# IREDELL COUNTY HEALTH DEPARTMENT

## IMPROVEMENT PERMIT / AUTHORIZATION TO CONSTRUCT / OPERATION PERMIT / EXISTING SYSTEM INSPECTION

PERMIT# 141808 PIN# 4712443267 DATE 5-14-07

SUBDIVISION EUFOLA FARMS BLOCK / SECTION LOT 9 LOT AREA 2.363 AC SITE CLASS. PS DESIGN FLOW 360 L.T.A.R. 125

INITIAL SITE SKETCH

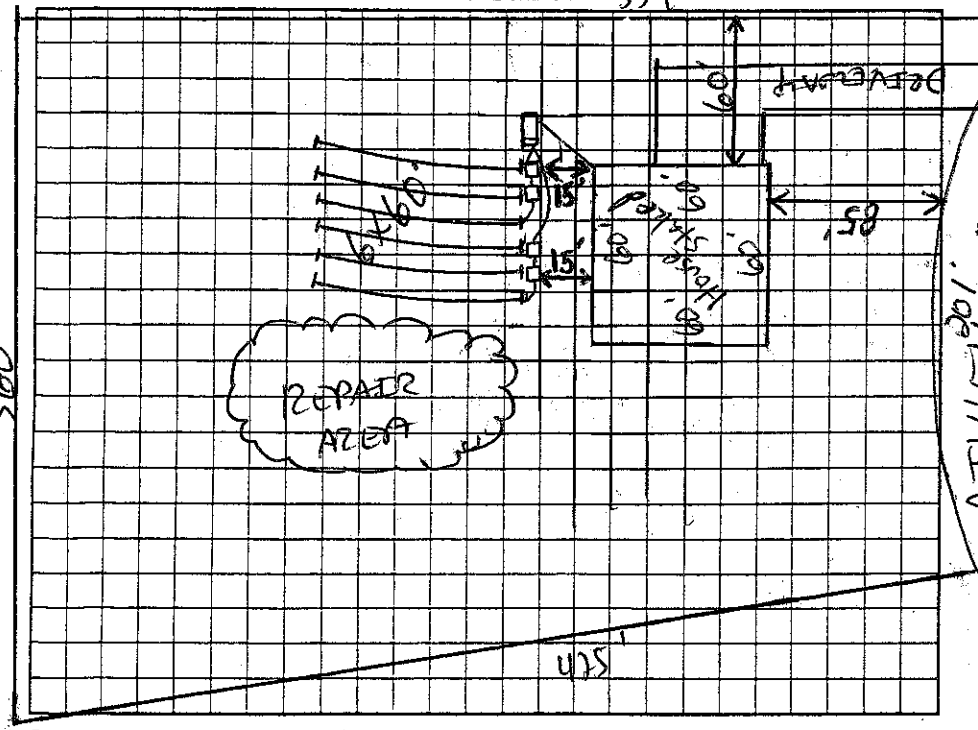
Comments:/Conditions: (1) Builder Requests 25% REDUCTION (2) INSTALL LINES ON Contours & maintain setbacks (3) INSTALL FLOW DIVIDER TEE & 4 Drop Boxes (4) Keep Basement Drain 15' From Septic TANK & Drainlines. Side Slope Setback

Comments:/Conditions: Upslope setback Should not be encountered if so... 25%

- 1st 2 LINES 20-24" DEEP DUE TO ROOTS & Stumps. MANGANESE Stains were in the last 3 lines & they were 18" DEEP
